6560-50-P

ENVIRONMENTAL PROTECTION AGENCY**40 CFR Parts 86 and 600****[EPA-HQ-OAR-2021-0208; FRL 8469-02-OAR]****Commented [LA1]:** This is the prior FRL number. There will be a new one for the final rule.**[RIN 2060-AV13]****Revised 2023 and Later Model Year Light-Duty Vehicle Greenhouse Gas Emissions Standards****AGENCY:** Environmental Protection Agency (EPA).**ACTION:** Final Rule.

Figure [SEQ Figure * ARABIC] EPA Final Industry Fleet-Wide CO₂ Compliance Targets, Compared to 2012 and SAFE Rules, the Proposal and Alternative, grams/mile, MYs 2020-2026 and later

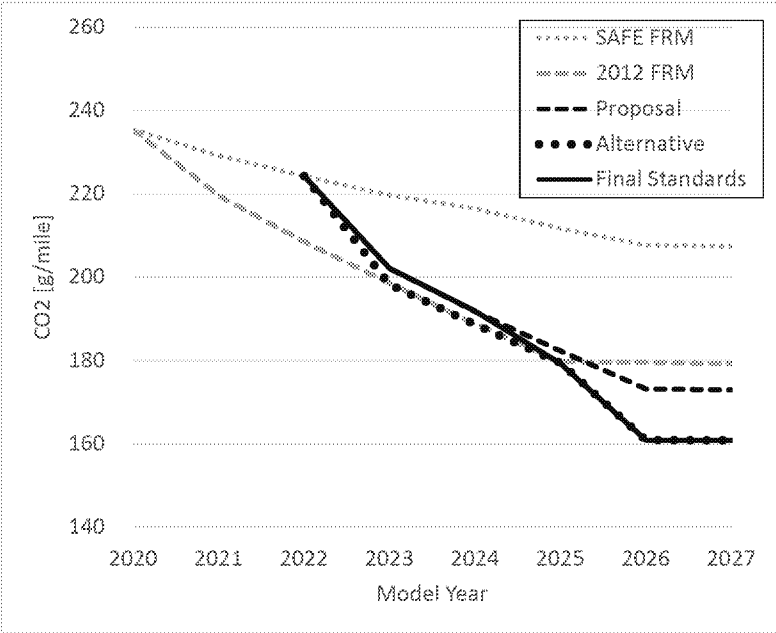
Commented [LA35]: It would be helpful to clarify the assumption (if I'm interpreting correctly) that the MY20 split is used for MY23-26, too. Otherwise, it is confusing why we would be noting MY20 here.

Figure [SEQ Figure * ARABIC] Final Standards Fleet Average Targets Compared to Alternatives

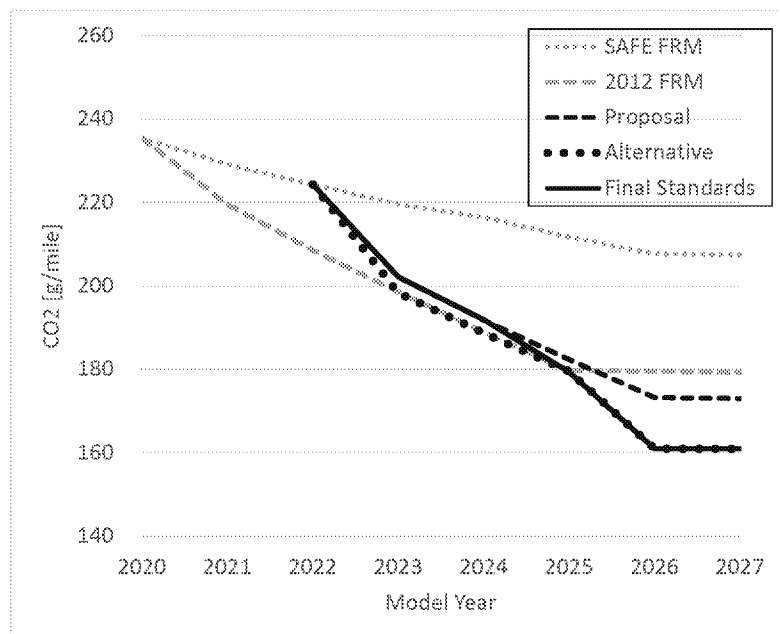
Commented [LA124]: Why does this not match the final rule 179?
